Elizabeth Street, Melbourne Flood Modelling Report

August 2017

MEMORANDUM

To Alex Barton, Asset Practitioner (Mapping & Modelling)
From Celine Marchenay, Group Manager ISWM, Water Technology
Date 13 February 2020
Subject Elizabeth Street Main Drain Catchment Flood Modelling

Figure 6-5 Manning's Roughness Polygons

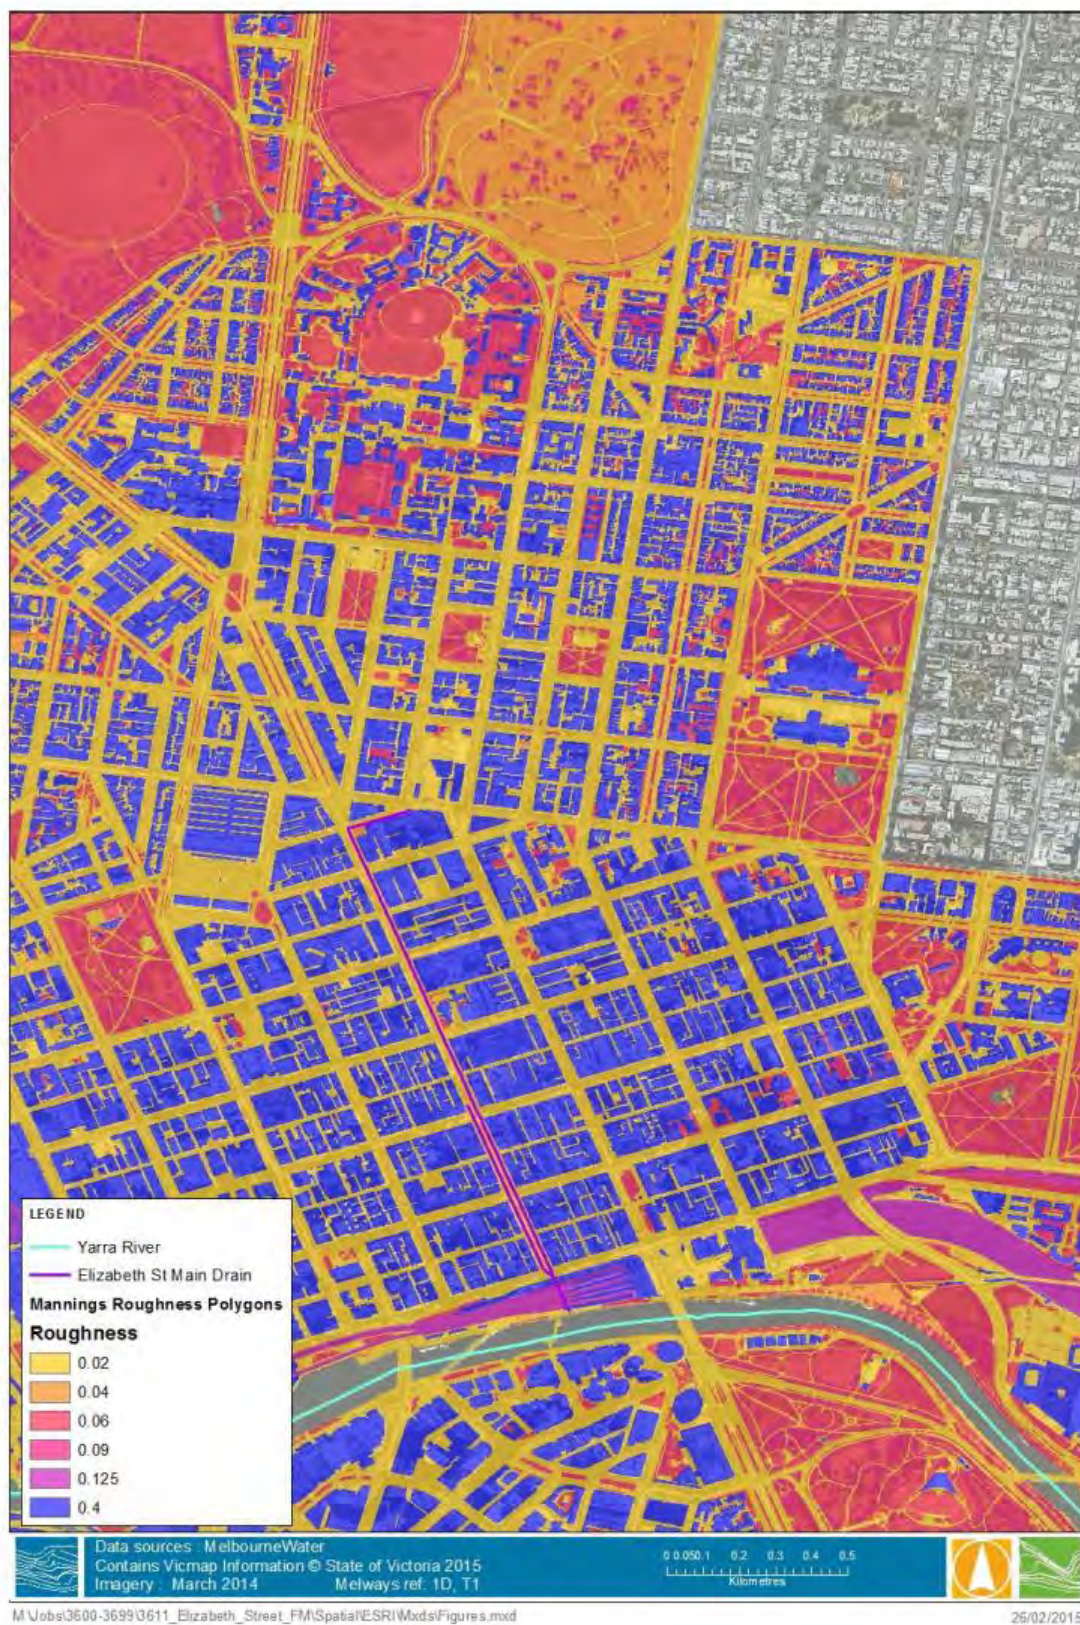
WT Clarification	No pit has had blockage applied to deliberately or non-deliberately in the latest hydraulic model issues to MW in December 2019 and currently been run under all the additional ARI and events. I am not aware of any pits that had deliberately been blocked in 2015 to 2017.
MW/CoM Question	There is a note saying the cemetery has a Manning's of 0.1 applied, Fig 6-5 suggests something lower. Please confirm if this is having any material influence on the final PSA extents being produced. (Page 25-26)
WT Clarification	I confirm that a Manning's value of 0.1 was applied over the cemetery and that Figure 6-5 is outdated.

Figure 6-8 Model Scenarios and Events

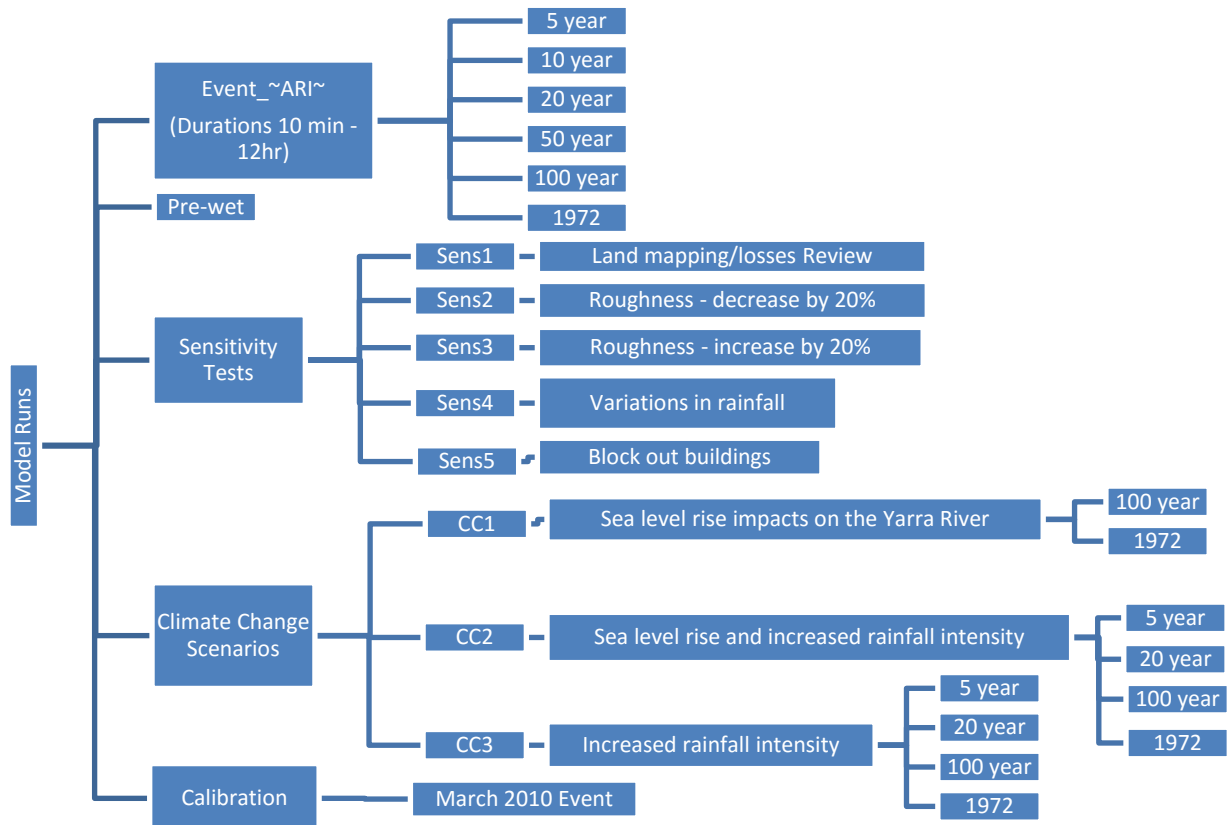
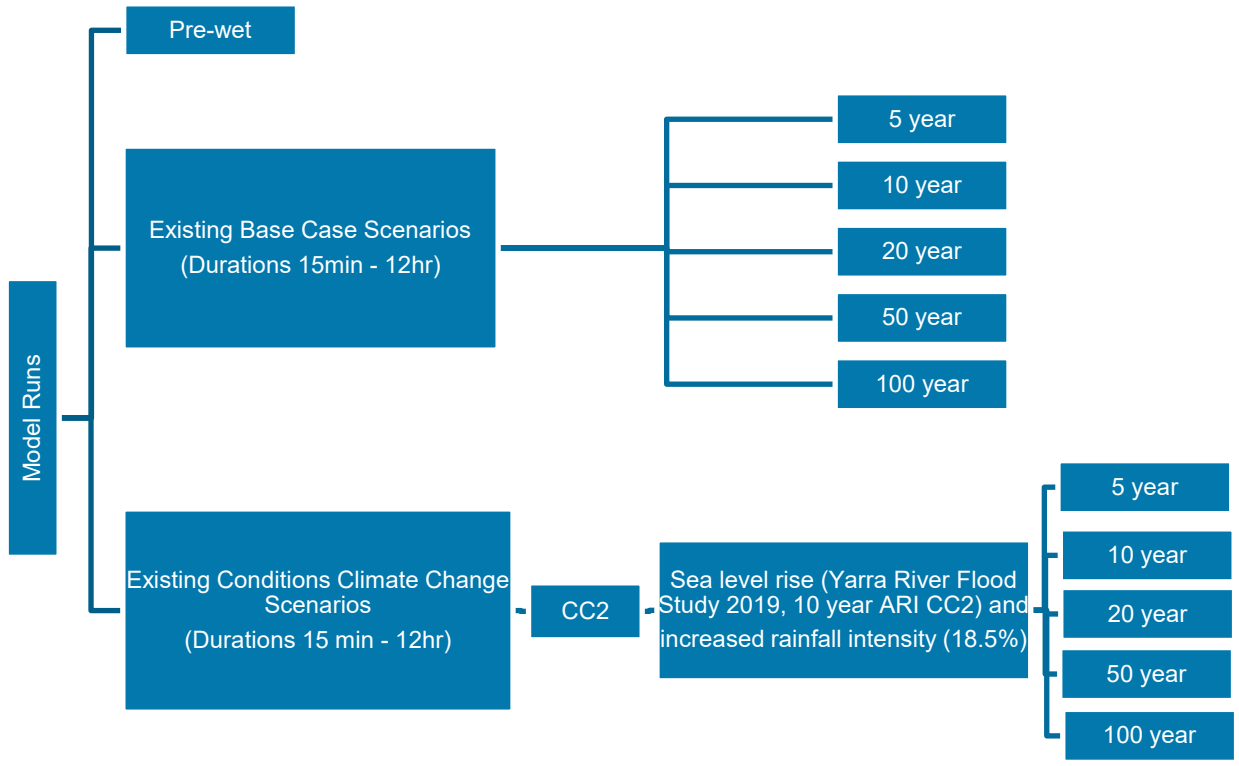
Description
MW/CoM Question	We believe an updated version of this figure would be very useful to show the new runs completed - is that possible? (Page 32, Fig 6-8)
WT Clarification	Revised Figure 6-8 is presented in Appendix A. Existing Base Case Scenarios simulations and results have been delivered in December 2019; Water Technology is now half-way through Stage 2 of the project re-running the Existing Conditions Climate Change simulations.

APPENDIX A – ELIZABETH STREET MELBOURNE
FLOOD MODELLING REPORT (WATER
TECHNOLOGY, AUGUST 2017) FIGURE 6-8 MODEL
SCENARIOS AND EVENTS REVISION

1d nwk issues

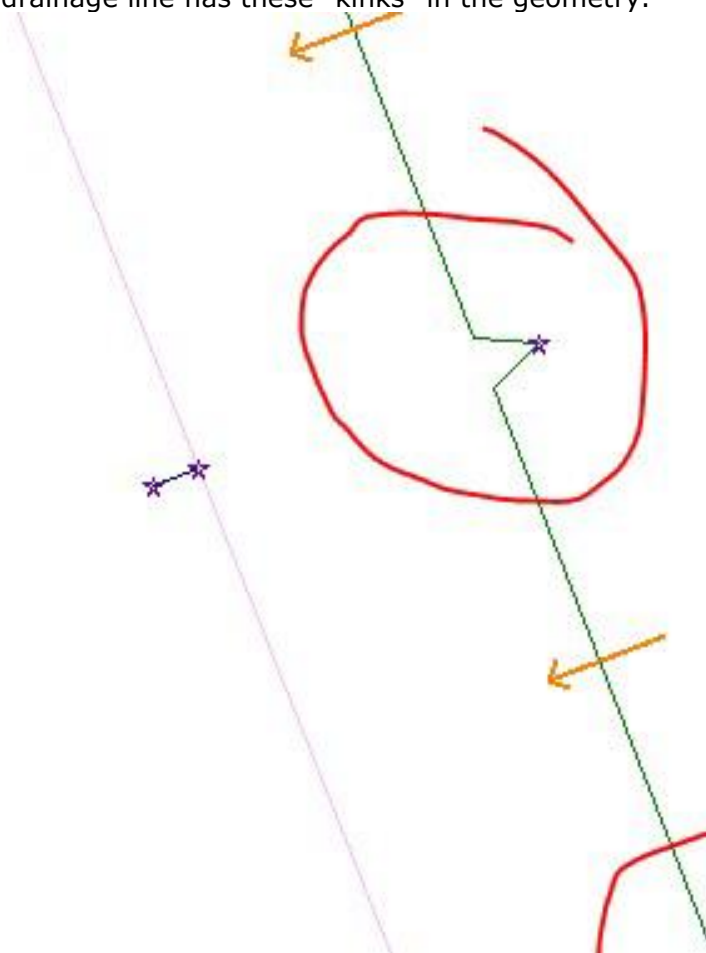
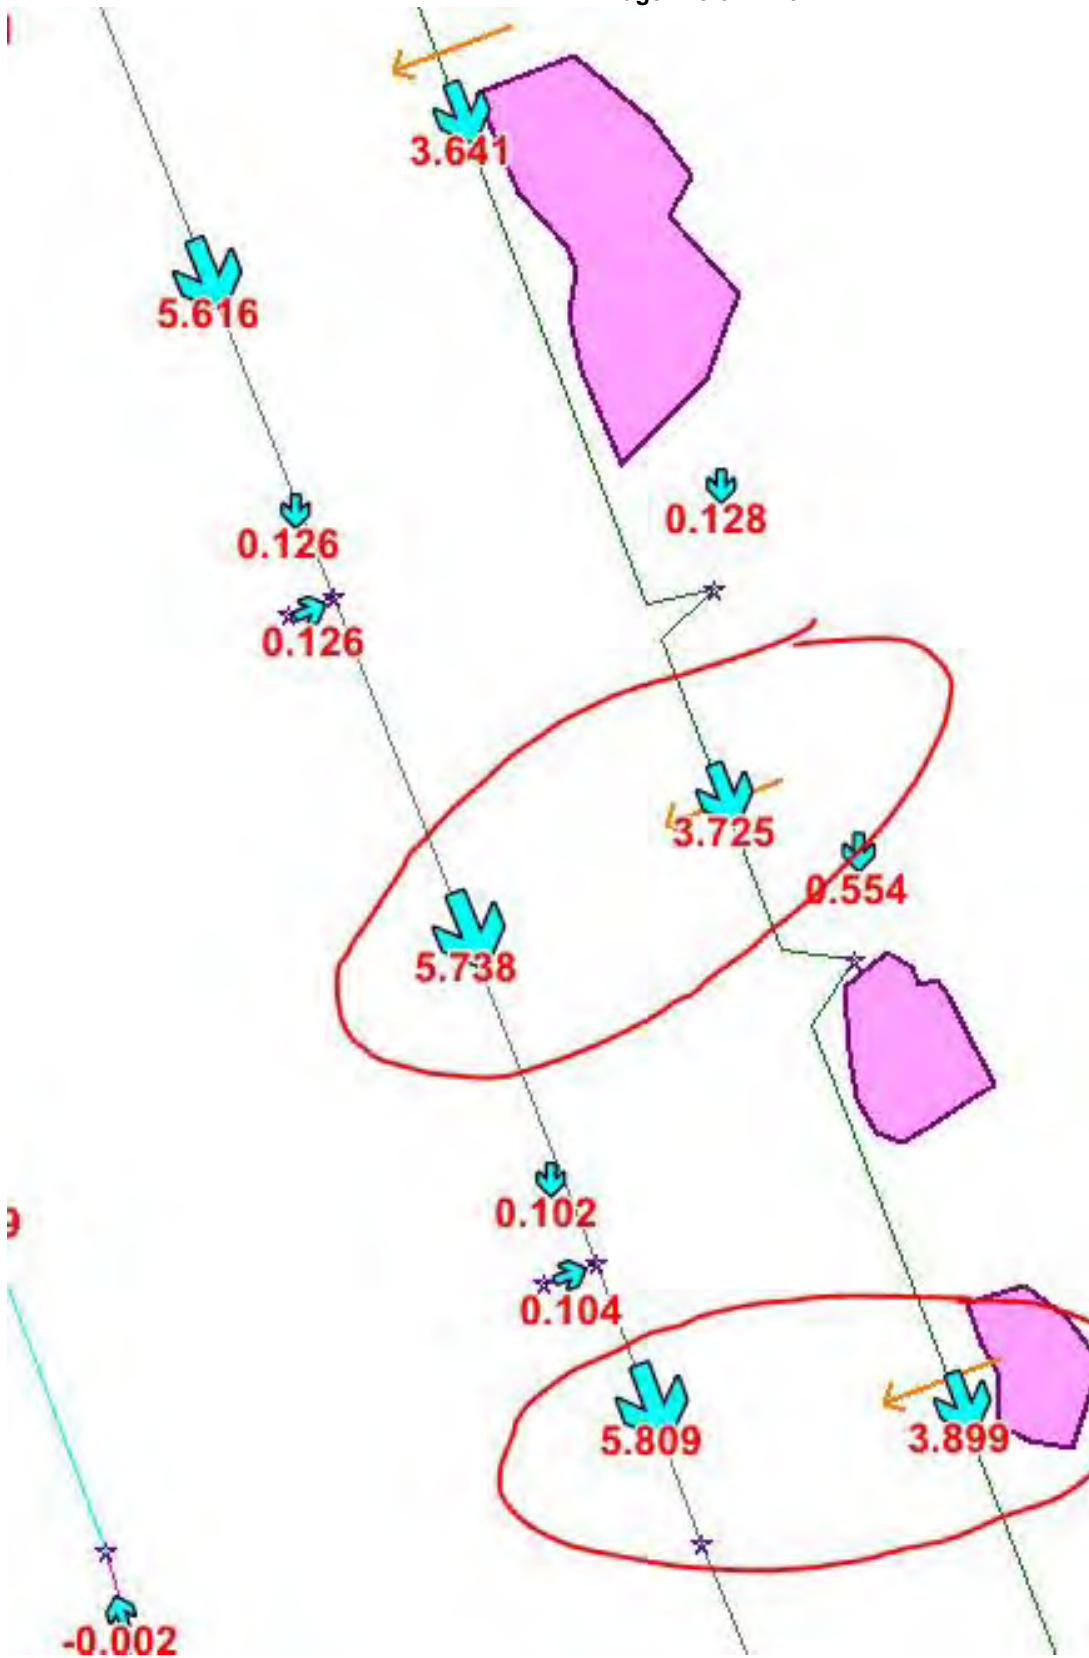
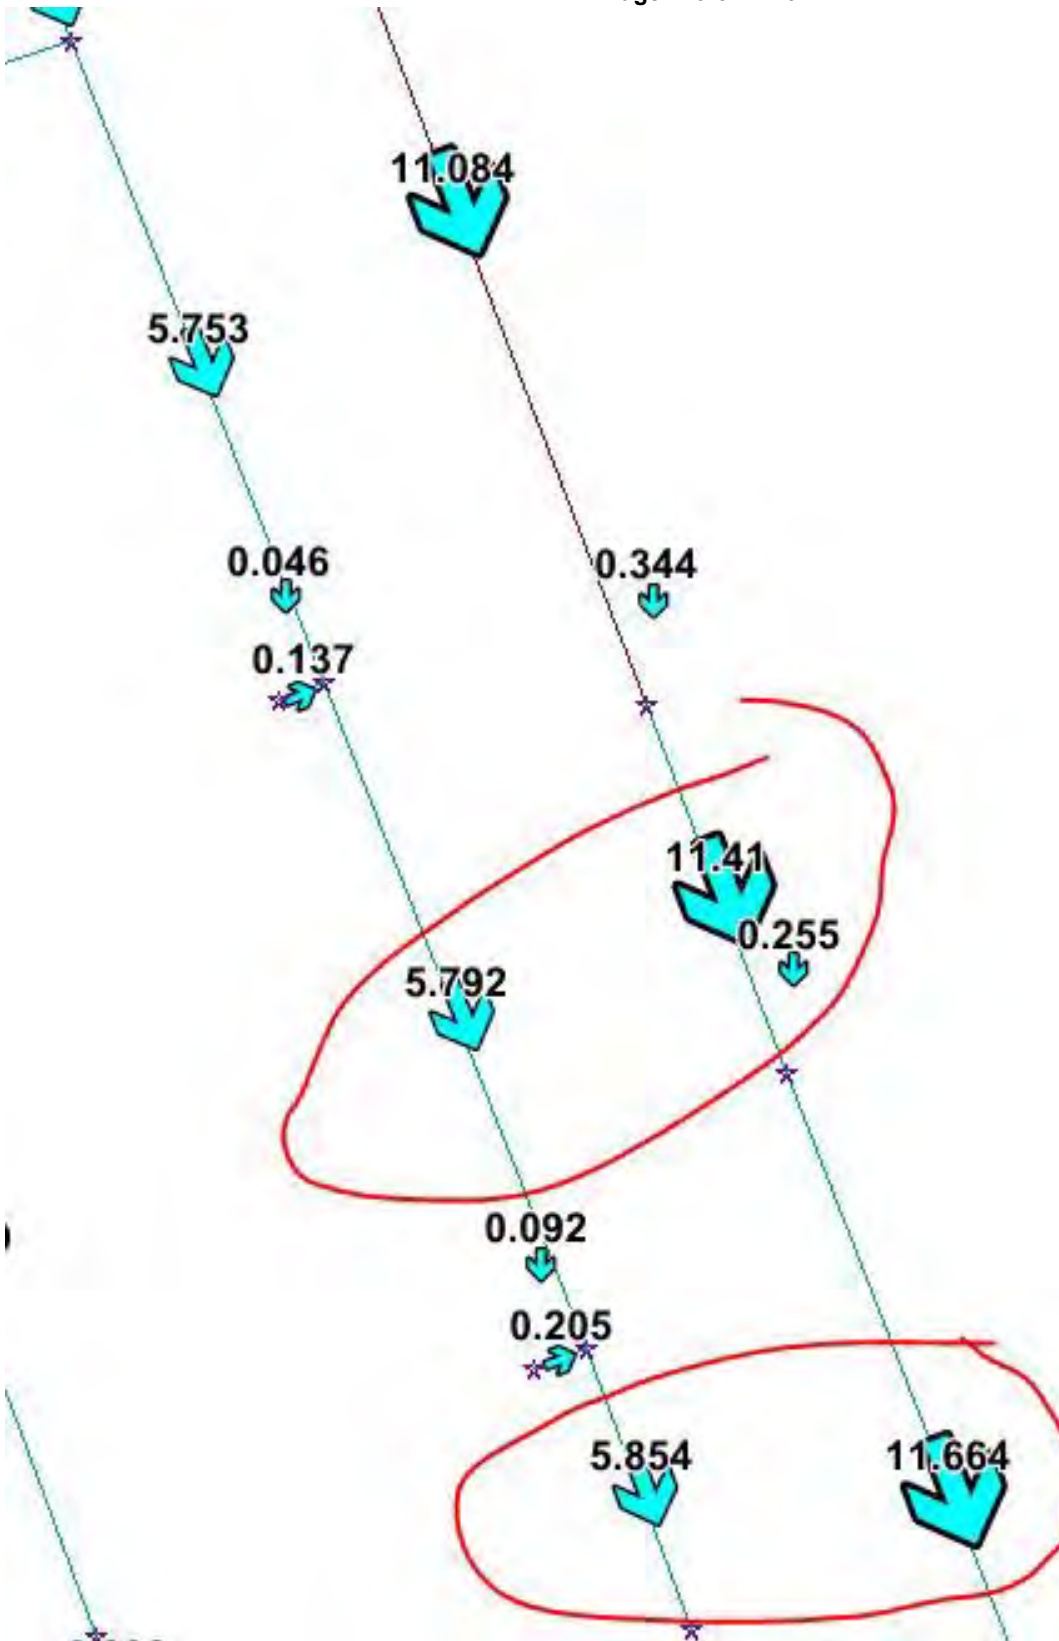
The main drainage line has these "kinks" in the geometry.

This is not appropriate since this changes how TUFLOW calculated losses for that pit using the Engelund method. TUFLOW thinks there is an actual bend in the pipe and adds very high losses. You can see this in TSL file.

Also if you look at the flow in the main barrel, you can see that the flow in the pipe drops significantly near these kinks. The smaller barrel is actually taking more water!

I ran a sensitivity model with the kinks removed and the flows changed to something more sensible.

If you need to connect to a pit that's away from the main channel, and you don't want to use short pipe lengths to avoid instabilities, consider using X connectors (type 'X' 1d_nwk lines) to connect them to the main trunk.

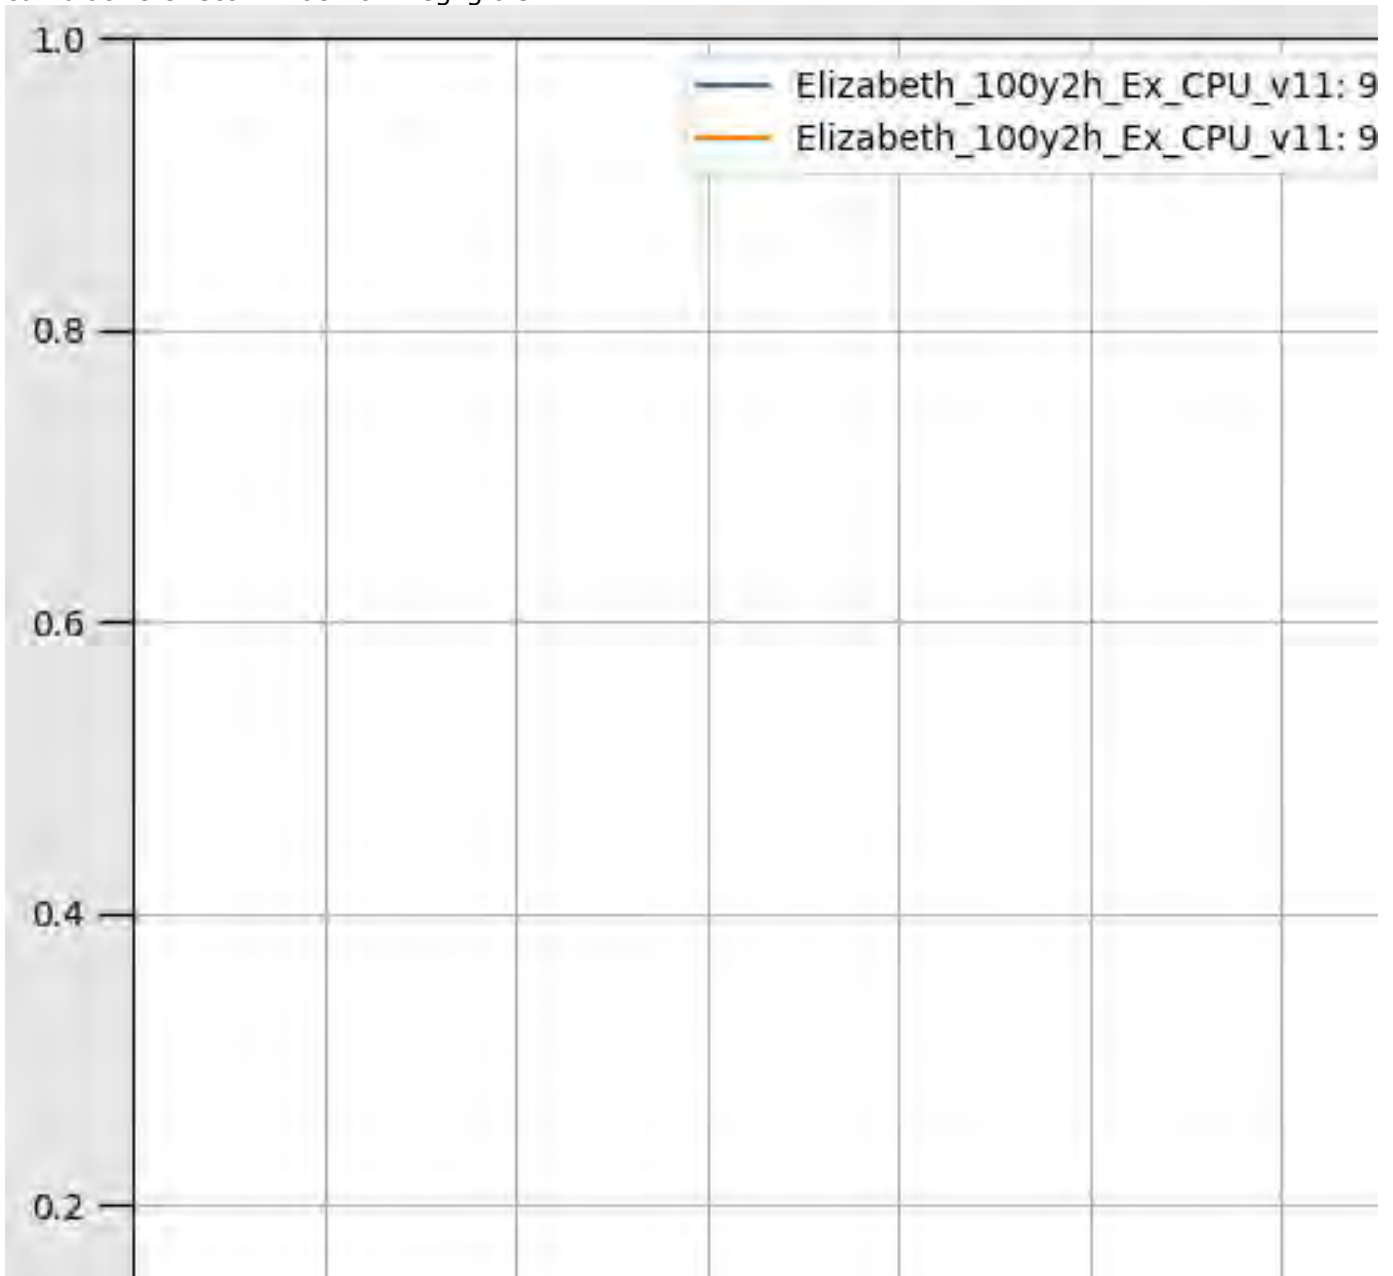
The high manning's values used to represent the buildings in the city are interacting adversely with the rainfall on grid approach of introducing flow. The water that falls on these high manning's areas are being attenuated and this removes the quick response you'd expect from an urbanised catchment.

I recommend using a depth varying manning's approach, with a low manning's value for shallow depth. I did some sensitivity with a manning's value of 0.02 for depths less than 50mm. This means that if the depths are small (i.e. rainfall on roofs), TUFLOW will convey that flow very fast off the property simulating the roof drainage infrastructure of the buildings. When the depths are high, the water will be attenuated as per a blockage. The depth varying manning's should only be done for building material types, not to all materials.

I think this will be crucial in getting flood depths in Elizabeth Street that are sensible. My sensitivity model shows depths in Elizabeth Street at the southern end almost doubling.
